<b>Office Action Summary</b>	<b>Application No.</b> 10/567,459	<b>Applicant(s)</b> LUPTON, HENRY WILLIAM	
	<b>Examiner</b> SEAN P. DOUGHERTY	<b>Art Unit</b> 3736

### **DETAILED ACTION**

This is the initial Office action based on the 10/567459 application filed 07/21/2006. Claims 76-97 are currently pending and have been considered below.

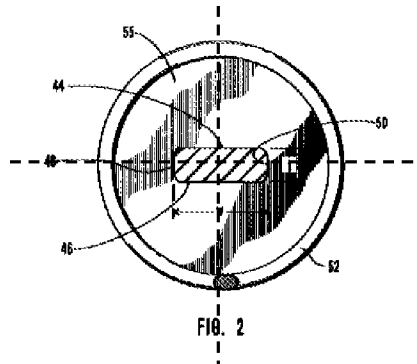
Regarding claims 76, 87 and 88, Backman disclose a elongated guidewire 10 in combination with a catheter (see title) for accessing a remote site in a subject, the elongated guidewire defining a longitudinally extending central axis through the center of step 31 extending axially between a distal end 22 and a spaced apart proximal end 14, a distal portion of the guide wire adjacent the distal end along section line 2--2 being of substantially rectangular transverse cross-section best seen in Fig. 2 defining a pair of spaced apart major surfaces (w), and a pair of spaced apart minor surfaces (t) extending between the major surfaces. Backman discloses a central major plane and a central minor plane as illustrated by the dashed lines below in Fig. 2. Furthermore, Backman discloses where the rectangular transverse cross-section of the distal end 22 is capable of being pre-bent into a desired orientation (col. 6, lines 36-45). Therefore, the distal end 22 is capable of being bent into a curved configuration in the central major

plane for forming an alignment portion (meaning, the distal end 22 is bent left or right in the orientation seen below in Fig. 2) at a degree greater than zero relative to the central axis. Note that the longitudinal axis of step 31 remains static as the distal end 22 is bent to form an angle in relation to the longitudinal axis of step 31.
